MACDONALDTOWN GASWORKS REMEDIATION PROJECT – EA SUBMISSION RESPONSE

Response to Strathfield Municipal Council Letter 'Submission to the Proposed Macdonaldtown Gasworks Remediation Project' dated 18 June 2012

Response to NSW Planning and Infrastructure Letter 'Macdonaldtown Gasworks Remediation Project (09-0145), EA Adequacy Review – Second Round', Revision 1

Figure 1: Macdonaldtown Remediation Proposed Site Setup

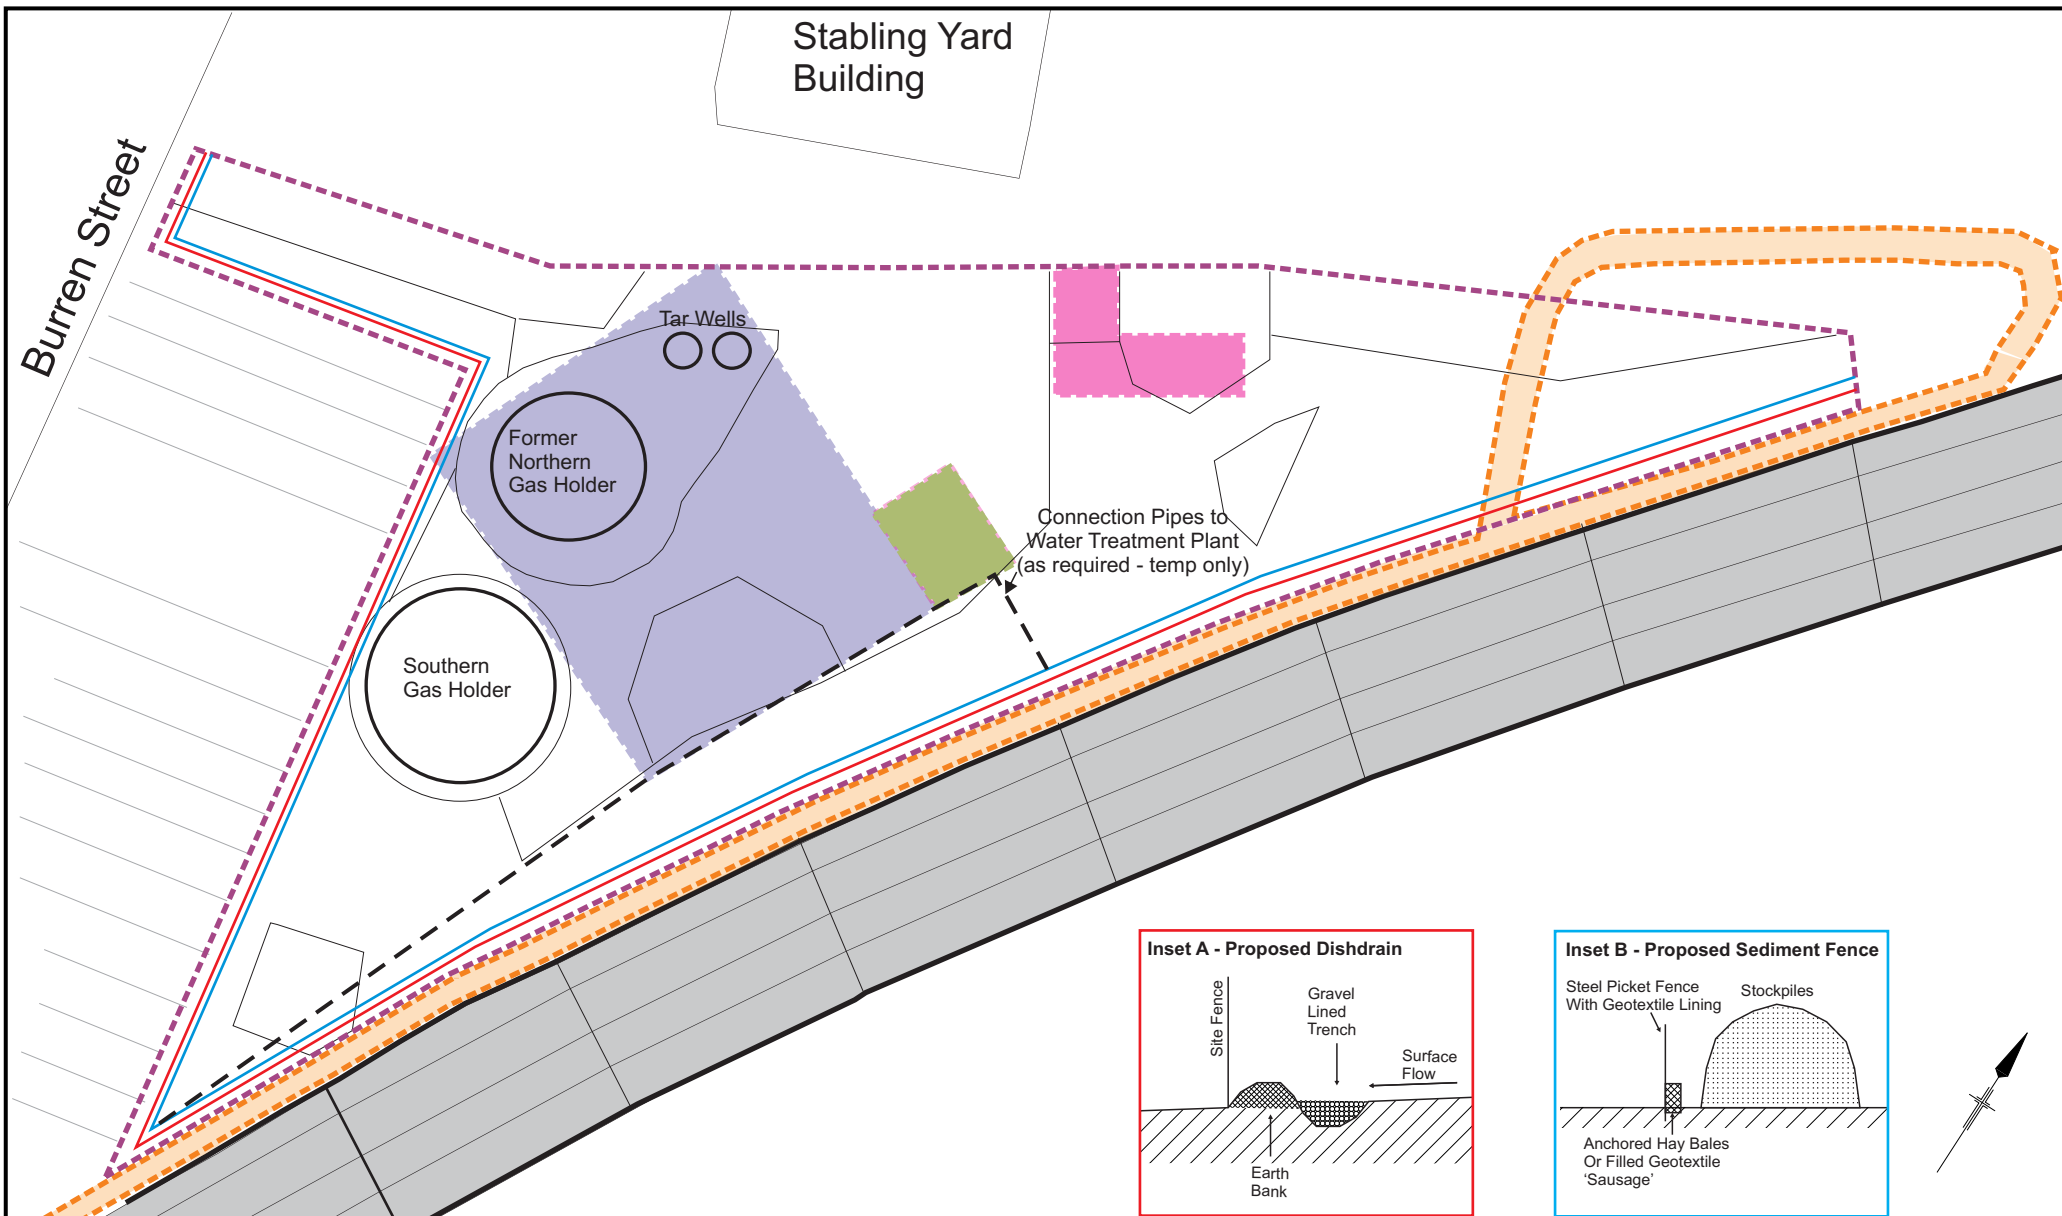
Comment 3: Soil and Water – please also provide a conceptual plan of the stormwater management at each site.

It is proposed that stormwater management be undertaken in accordance with '*Environmental Management Plan, Demolition and Remediation, Former Macdonaldtown Gasworks, Burren Street, Erskineville, NSW*', (JBS 2011e). Specifically EMP Procedures 11 and 30 in JBS (2011e) provide management procedures for stormwater and sediment control during the proposed works. **Figures 1 and 2 (Attachment 3)** provide a conceptual plan of stormwater controls at each site, in accordance with EMP Procedures 11 and 30, and based on the proposed layout at each site during remediation.
